Certificate of Appropriateness Application

BAR 20-12-04

106 Oakhurst Circle

City of Charlottesville
Board of Architectural Review
Staff Report
December 15, 2020

02 BALCONY RAILING DETAIL (WORKING)
 SC: 1 1/2" = 1'-0"

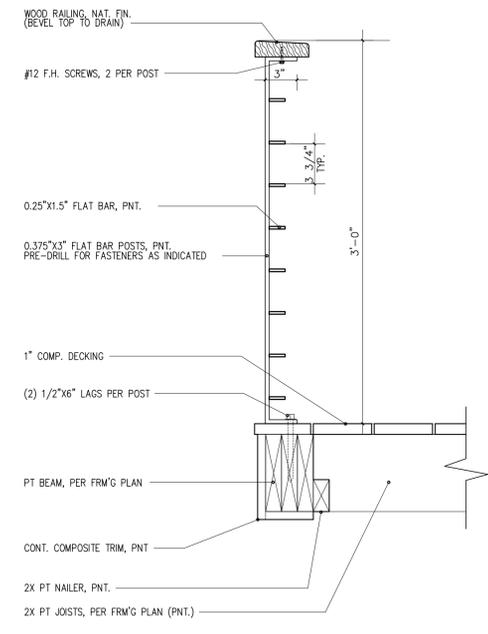
- Balcony railings: Refer to detail, sheet C. Graphic represents “typical” construct of painted steel frame (to match trim) & wood cap.
- West balconies (Unit B): no longer has side wall plane to ground; redesigned as open condition with ‘tilted’ support column intended to subtly compliment the slope of the site and as homage to ‘leaning’ nearby oak that will need to be removed.

E-Series French Casement Window

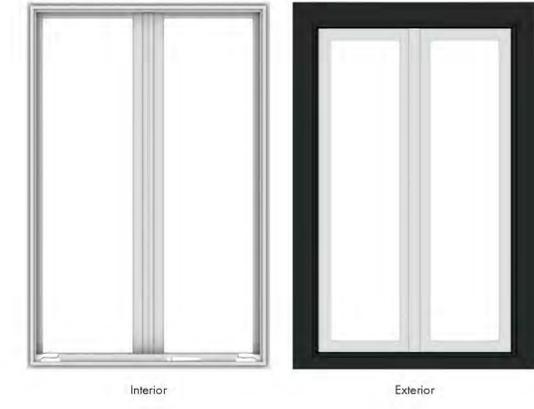
Doors and Windows: Submittal indicates insulated glass with an applied grille. BAR should require an internal spacer bar within the glazing.

- Windows/doors: Aluminum clad wood units by Anderson (see exhibit, sheet C) that follow the existing scheme of French casements as the dominant type. White sashes with casings and sills to match existing. Muntin patterns respect existing without replicating.

SOUTH PORCH DETAIL

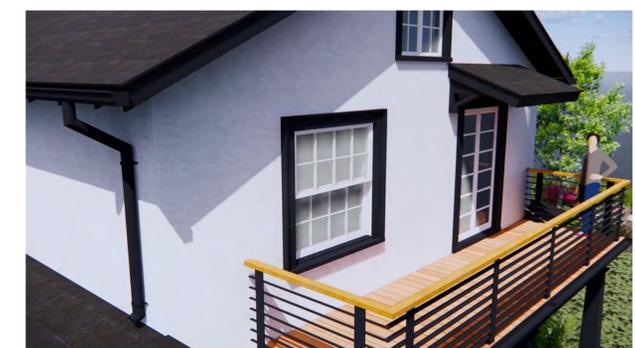
- South porch: Now includes More developed roof brackets (see 3D detail, sheet D).
- Front Porch: Not a focus of our attention previously, but now being considered in concert with the reimagined front yard/garden, to be “spruced up” with new slate pavers & seat walls of stucco to provide sense of enclosure and engagement with landscape and street life beyond.
